Re: Valley Truck Leasing

Valley Truck Leasing is submitting our revised plans/documents consisting of two (2) 24x36 drawings, two (2) 11x17 color drawings. Note: per your email dated November 9, 2023, the following numbered items 1, 2, 5, and 6 have been addressed on the revised submitted plans.

PROPOSED NEW BUILDING FOR:
VALLEY TRUCK LEASING
AMERICAN DRIVE, NEENAH WI 54956
FIRST FLOOR PLAN

2024 Valley Truck Leasing Building

NORTH ELEVATION
 1/8" = 1'-0"

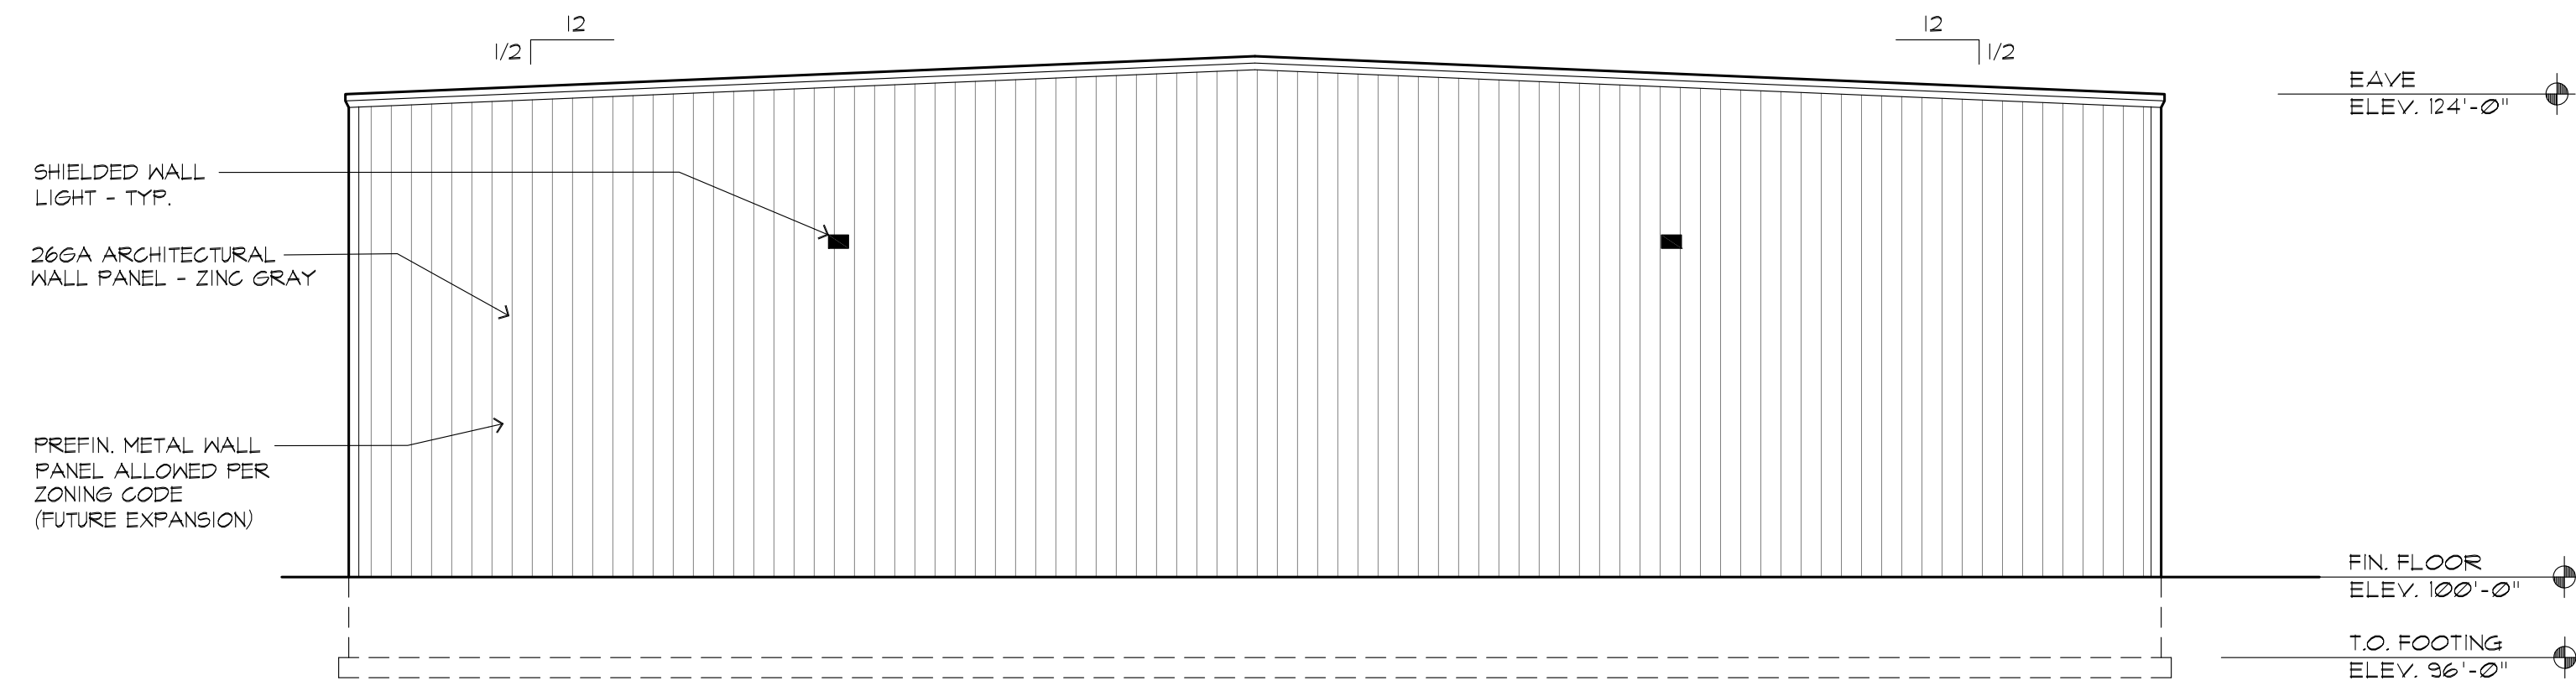
#3 – Exterior wall materials do not comply with the requirements of attachment C, Architectural Design Standards, of the Town Zoning Ordinance:

North elevation is Valley Truck Leasing's future expansion wall which will be ordered with an expandable end wall frame. The projection for the future expansion is 5 years or less. At the time of expansion, we would be agreeable to have the same amount of masonry that matches the shop east and west elevations. The south elevation, if the ACM panel would be acceptable, our wall surface would be at 74.5%. The east and west office only elevations without ACM panel are 75.5%, including ACM panel 81%. Shop east and west elevations have a total of 13% acceptable building materials. It is the intent of the owner to develop Phase II per the preliminary site plan C2.0. Once the buildings have been built, driving east on West American Drive it will be hard to see the shop. Traveling west on American Drive, based on the narrow width from the building's east elevation to the east parking lot along with the additional evergreen landscape and the angle of West American Drive, it would be difficult to see the shop's east elevation. Valley Truck Leasing's design is compatible and consistent with adjacent properties, and we would ask the planning commission to waive to 75% exterior wall surface requirements on the shop portion only.

BUILDING ELEVATIONS

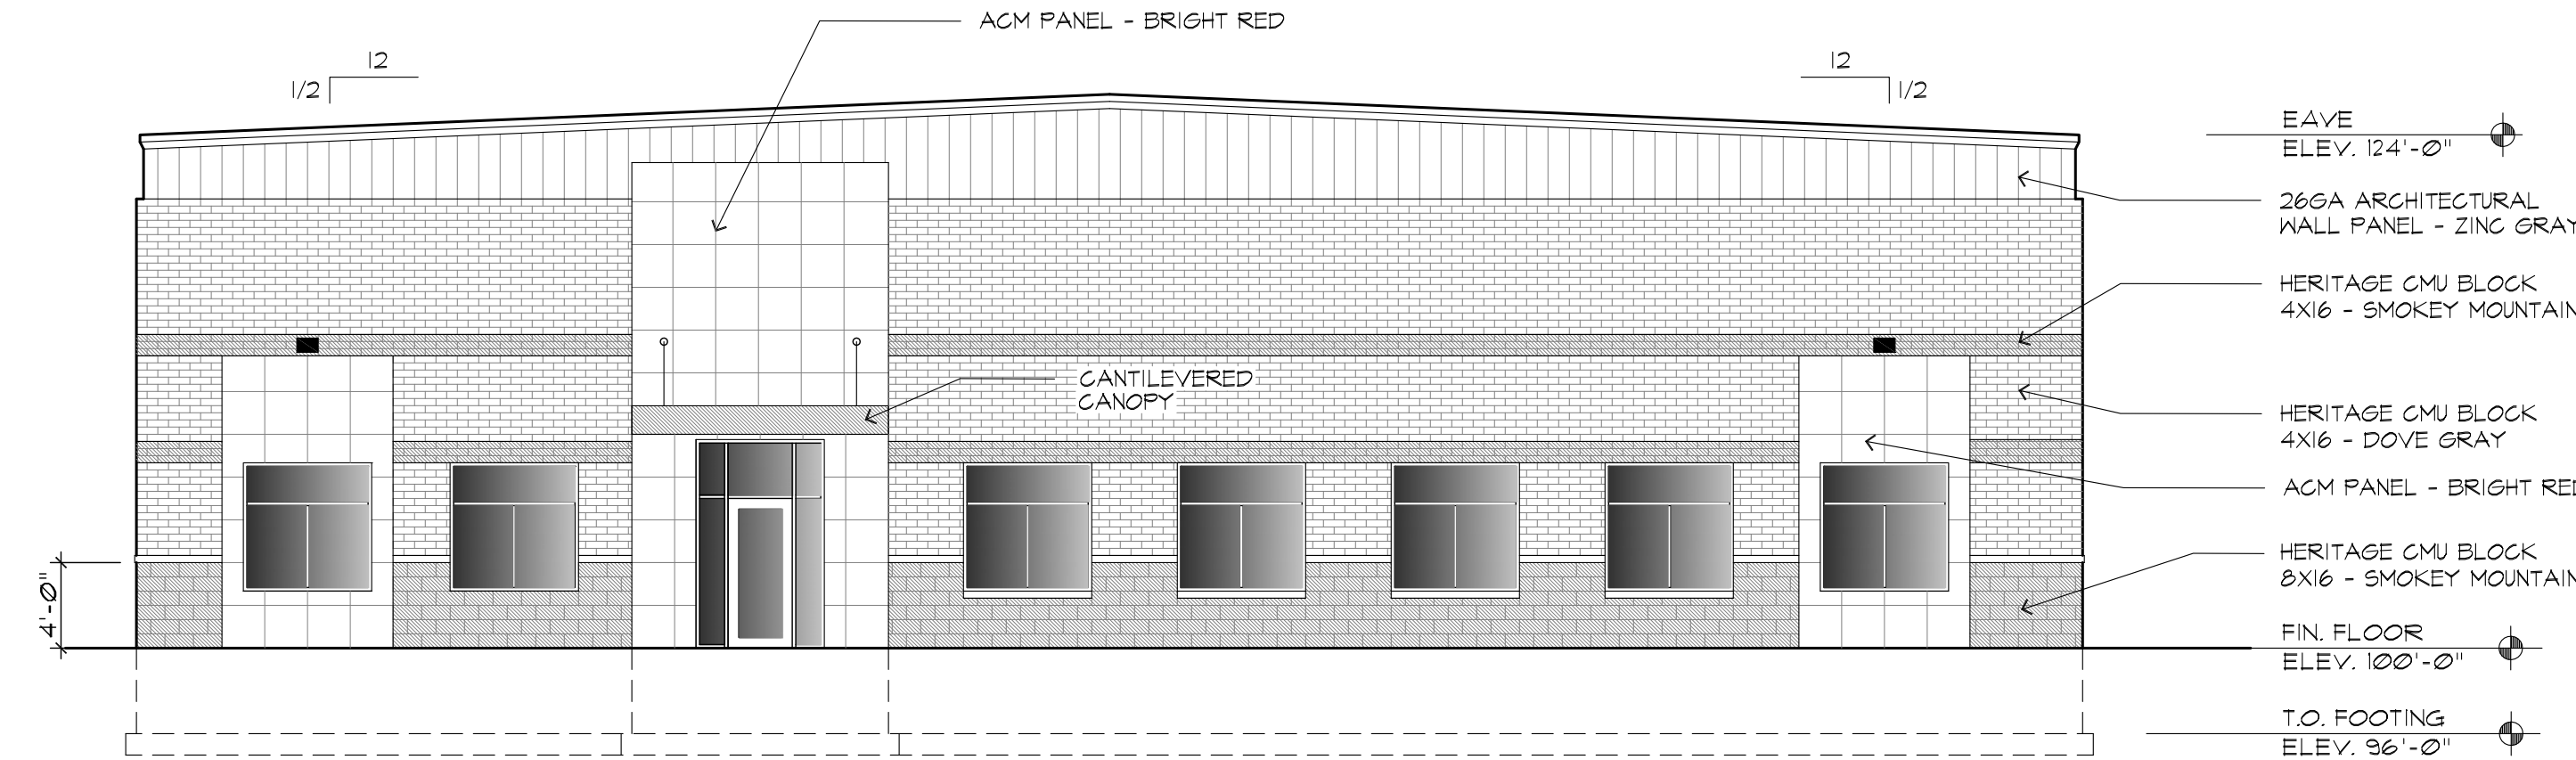
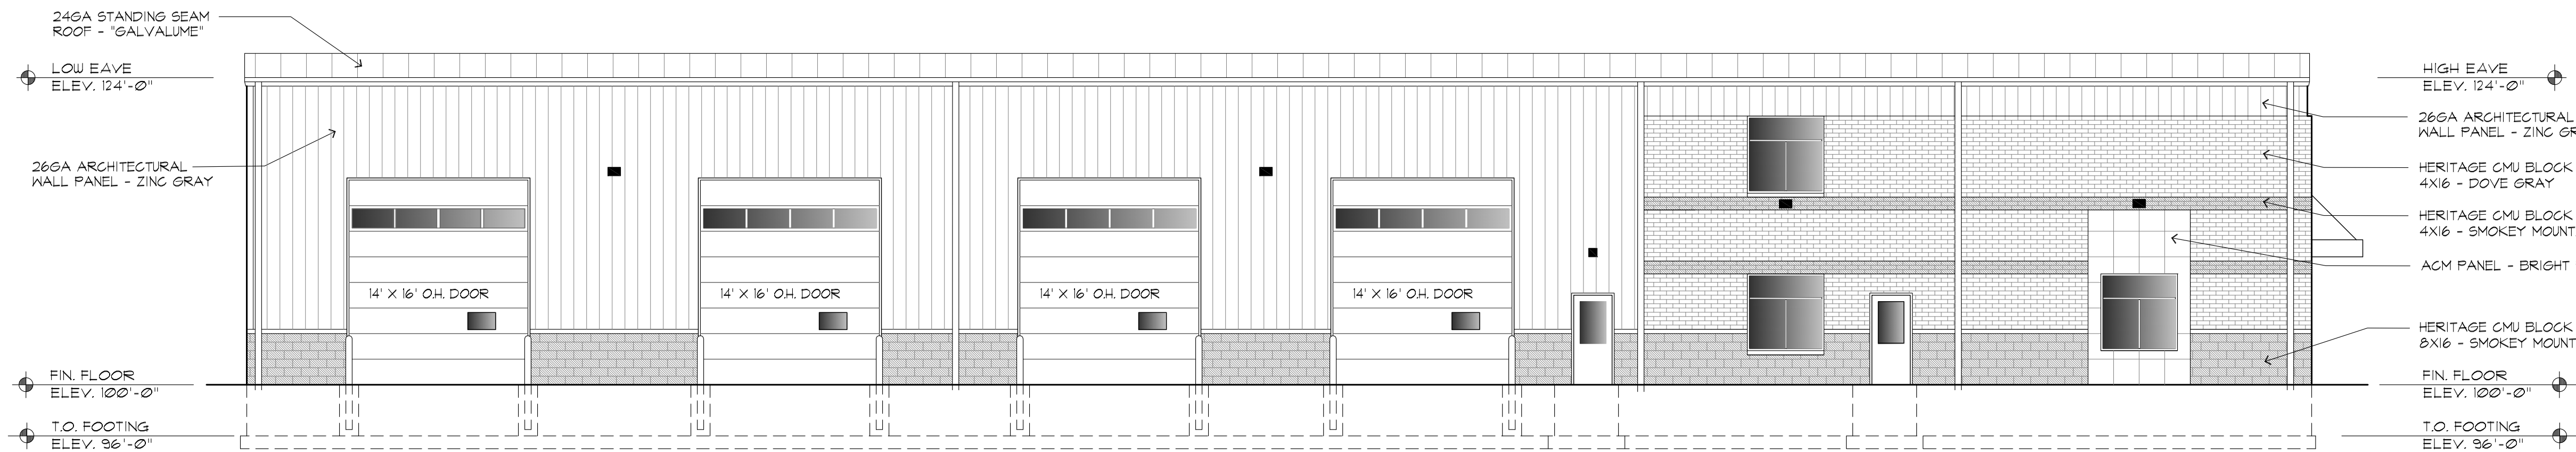
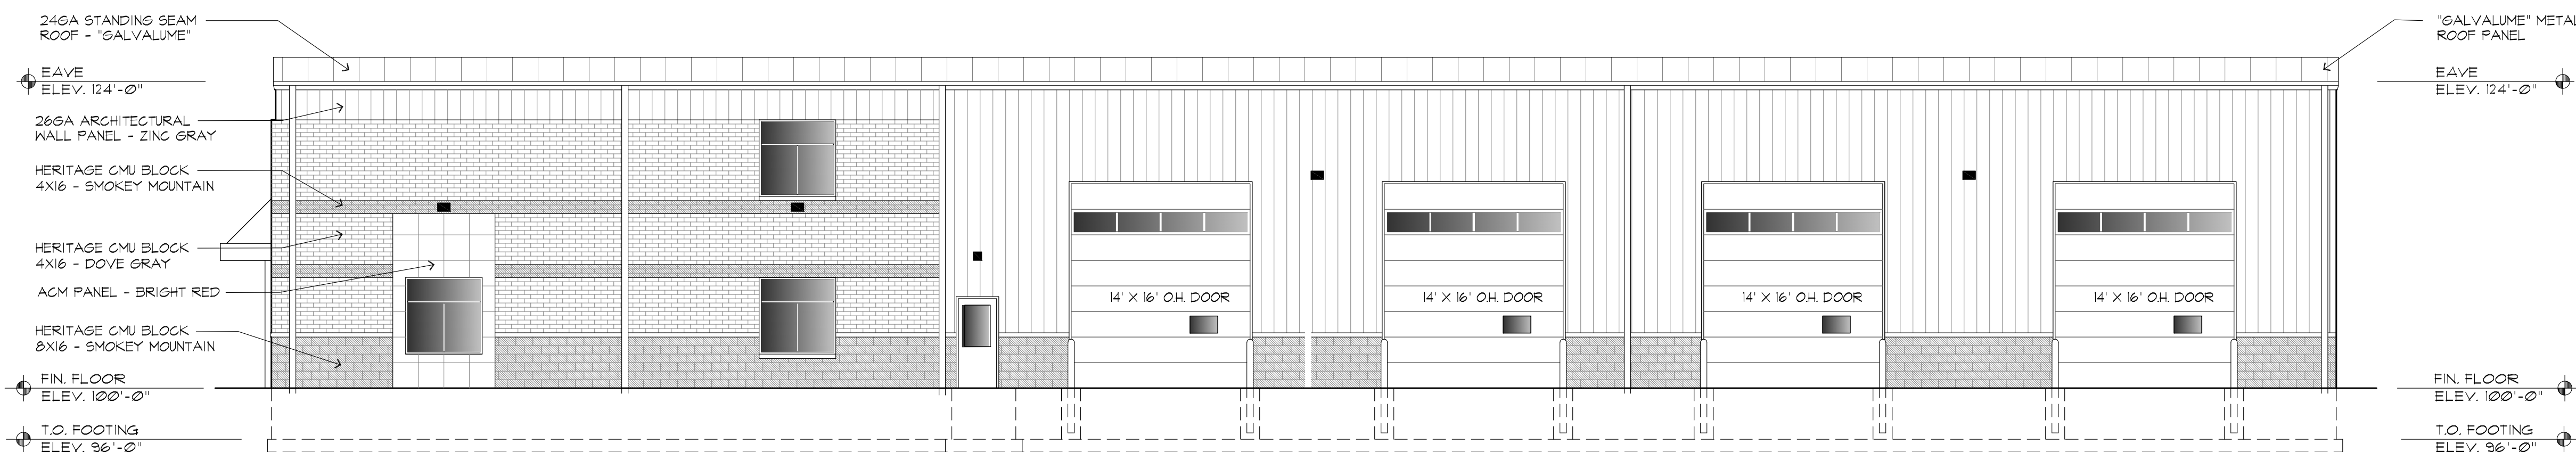
WE ARE REQUESTING THE VILLAGE TO APPROVE THE EXTERIOR ELEVATIONS WITH LESS THAN 75% ACCEPTABLE PRIMARY ELEVATION MATERIALS, SINCE THE VILLAGE HAS THE AUTHORITY TO ALLOW A DECREASE IN THOSE MATERIALS. WE FEEL WE MEET THE ARCHITECTURAL DESIGN INTENT OF THE ORDINANCE SINCE OUR SOUTH (FRONT) ELEVATION IS DIVERSE WITH (2) TYPES OF METAL WALL PANEL, & (2) TYPES OF MASONRY. THE EAST & WEST ELEVATIONS HAVE MASONRY AT THE BASE, AND OVERHEAD DOORS TAKE UP ABOUT HALF OF THE WALLS AS ALLOWED BY ZONING. THE PRIMARY FUNCTION OF THE BUILDING IS SERVICE RELATED WHICH REQUIRED THE OVERHEAD DOORS.
 THANK YOU FOR YOUR CONSIDERATION.
